SUBJECT: Transmittal of Westinghouse Responses to US NRC Requests for Additional Information on the AP1000 Application for Design Certification

AP1000 DESIGN CERTIFICATION REVIEW

Response to Request For Additional Information

Figure 650.004-1 AP1000 IRWST Plan View

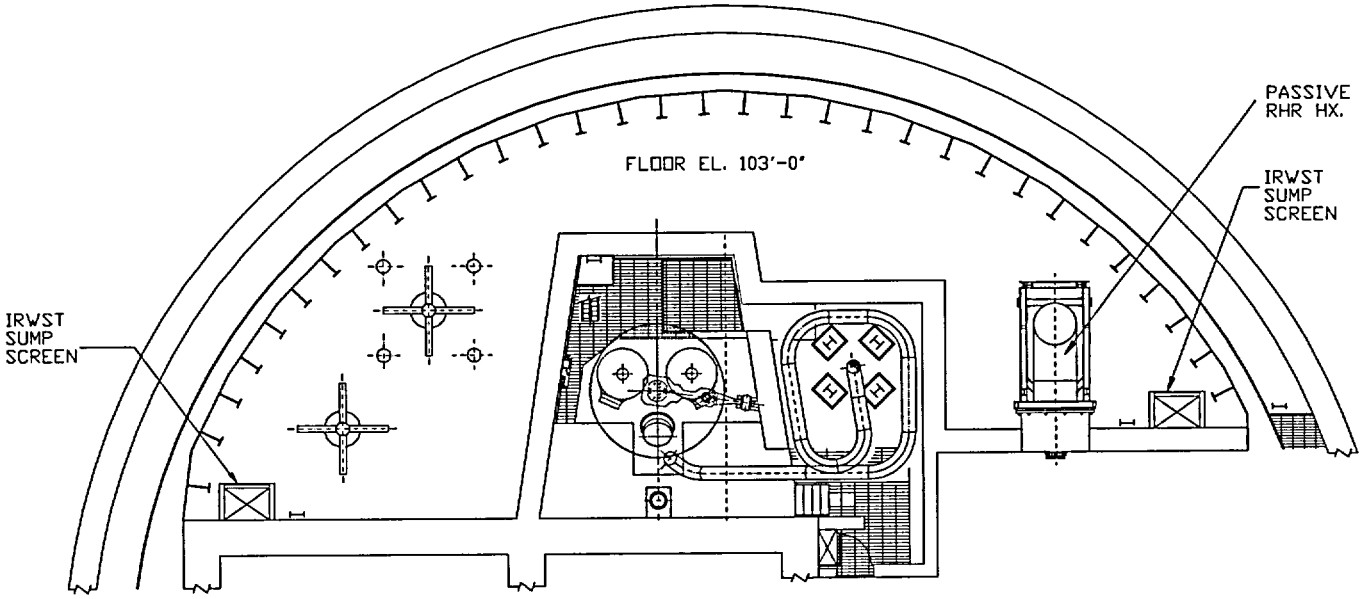
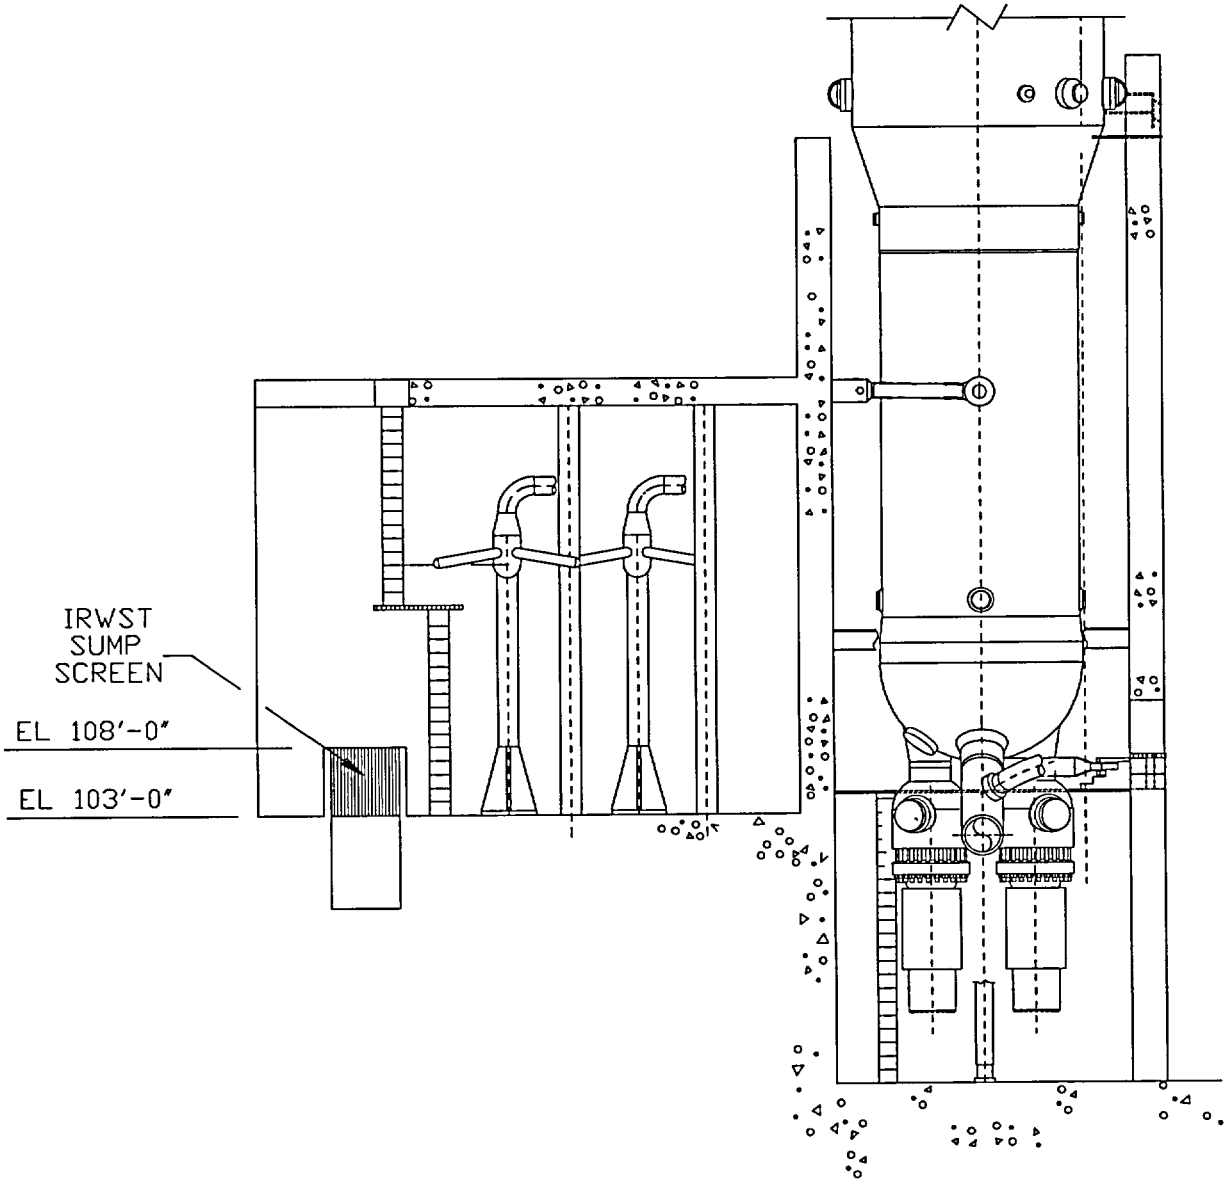
Section 6.3.2.2.3 of the DCD, entitled In-Containment Refueling Water Storage Tank, states that [t]he IRWST is stainless steel lined and does not contain material either in the tank or the recirculation path that could plug the outlet screens. Though the water in the IRWST would likely be relatively pure, the staff believes it is not likely to be completely free of debris, particularly considering the debris-concentrating potential afforded by the cycling of the IRWST inventory during refueling outages, and the opportunity for any suspended debris to settle to the IRWST floor during long periods of stagnation. The staff notes that as little as 1.5 cubic feet of fibrous debris could potentially cover both IRWST screens, which is a very small fraction of the tank's capacity of 73,900 cubic feet. If an automatic depressurization system (ADS) actuation occurs during an accident condition, any debris residing on the bottom of the tank (including heavier particulate matter) could be easily re-suspended by the consequent induced turbulence. Considering these NRC staff observations, please provide further information to clarify why fibrous and particulate debris settling onto the tank floor is not a concern for the IRWST screens, and clarify that the analysis concerning debris transport and head loss provided accounts for the most limiting IRWST conditions (e.g., during potentially turbulent conditions and at reduced tank levels as the switchover to recirculation approaches).

What is the basis for the conclusion in the RAI response that ". . . any resident debris that might have settled on the IRWST floor prior to an accident is not likely to be stirred up by the ADS . . . ?" That is, what sort of analysis has been done to demonstrate that the turbulence conditions within the IRWST are sufficiently low at the floor of the tank during an ADS actuation?

The IRWST is a stainless steel lined storage tank located inside containment. Refer to Figure 650.004-1 and -2. The tank is normally closed off from the containment although there are large louvered vents located through the IRWST roof. The tank is 30.25 feet high (inside floor to ceiling). The tank extends around part of the containment from the refueling cavity past the pressurizer and is about 120 feet across. There are two ADS spargers located in one side of the tank. The bottom of the sparger arms are located about 16 feet above the floor of the tank. There are two separate PXS injection line connections from the bottom of the IRWST. Line A is on the ADS side and line B is on the other side with the PRHR HX. Each of these lines is protected by a screen assembly. Line A has a connection to the Spent Fuel Pool Cooling System (SFS) pumps. This line allows the SFS to recirculate the water in the IRWST to provide

As discussed above significant quantities of debris are not expected to settle out in the IRWST during normal operations. Even if such debris **did**~~were to have~~ settled onto the IRWST floor, **they are**~~it is~~ not expected to be stirred up in the limiting accident. **The basis for this statement is the discussion of the ADS design and plant behavior presented below and the observation of test results from the Low-Pressure Integral Systems Test at Oregon State University. OSU has a scaled ADS sparger. OSU test SB-12 is a DVI LOCA; it shows that the temperature near the bottom of the IRWST (below the PRHR HX bottom) shows essentially no temperature change out through ADS 4 actuation (Reference 1). Although this test was performed for AP600, the design of the IRWST, the ADS sparger and ADS stages 1, 2, 3 have not been changed for AP1000. As a result, the conclusions also apply to the AP1000.**

Figure 650.006-1 AP1000 Coating Debris Settling (Front)

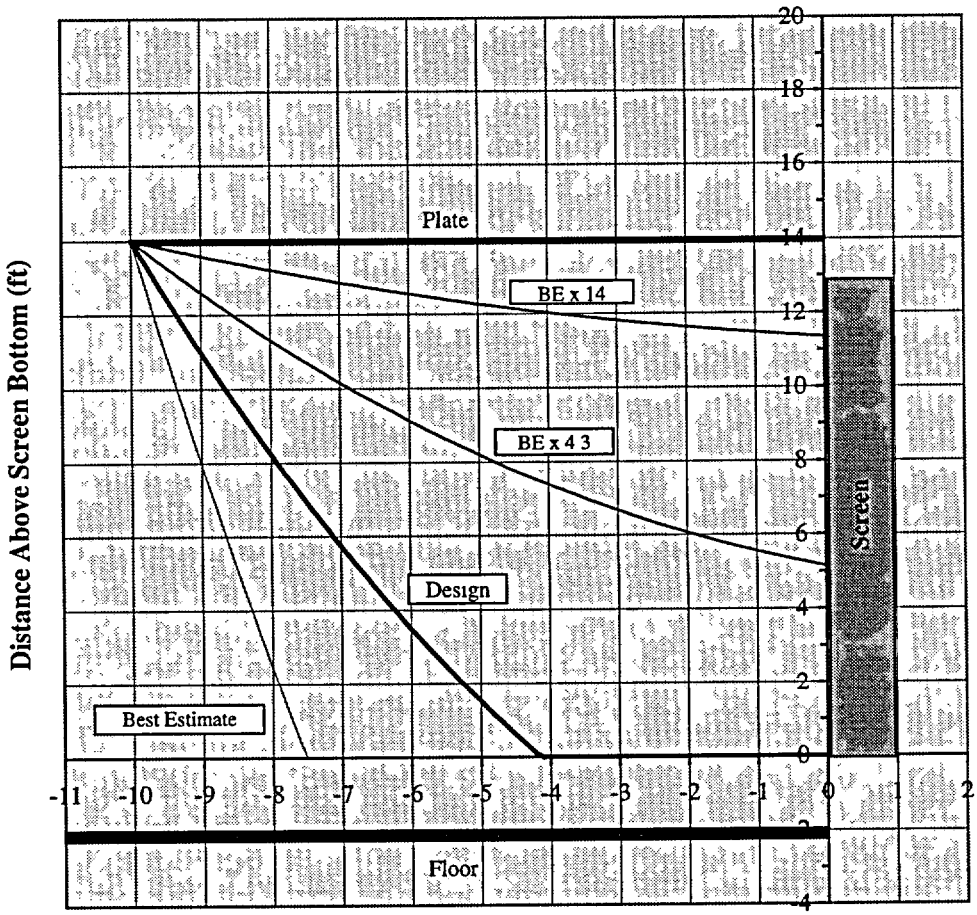
What is the basis for using 200 mils as the diameter for postulated coating debris? Experience shows that much smaller flakes are possible, and smaller flakes would tend to settle more slowly than would the larger diameter flakes assumed in the calculation, presenting a potentially greater challenge to the sump screen. When potential resident fiber loadings are considered, flakes significantly smaller in diameter than 200 mils are presumably large enough to become trapped at the interstitial locations of the lattice formed by a fibrous debris bed. Although they presumably represent particles smaller than 200 mils, it is not clear exactly what flake sizes correspond to the bounding settling calculations (i.e., B.E. x 4.3, B.E. x 14), and thus it is not clear what degree of conservatism is being employed when considering the sizes of flakes that can be generated through known failure mechanisms.

Figures 650.006-1 and -2 show the settling trajectories of coating debris starting at the edge of the protective plate. Figure 650.006-1 shows the approach from the front of the screen and figure 650.006-2 shows the approach from the side. Such debris can not enter the water any closer to the screens because no coatings are permitted any closer to the screens. The figure shows that with design settling rates the debris will settle to the elevation of the bottom of the screen after drifting about 6 feet, which is at about 4 feet away from the screen. Significant conservatism was included in this evaluation, including assuming the lightest/smallest coating debris. **The minimum debris size was selected as a disc 200 mils in diameter and 5 mils thick. The 200 mils was selected as the smallest size that**

It also assumes the maximum recirculation flow of 1600 gpm, consistent with the maximum flow from two RNS pump operating unthrottled with suction taken from two screens. Another area where significant margin has been applied is in the debris settling rates. AP1000 uses debris settling rates that contain a factor of two margin compared to the reference settling data (Reference 1) which is sufficient to account for uncertainties. Without this added margin, the coating debris settles out very quickly in less than 3 feet, as shown in Figure 650.006-1 and -2.

The debris settling shown in figures 650.006-1 and -2 provide confidence that the plant can sustain complete failure of the nonsafety-related coatings located inside containment without excessive blockage of the recirculation screens.
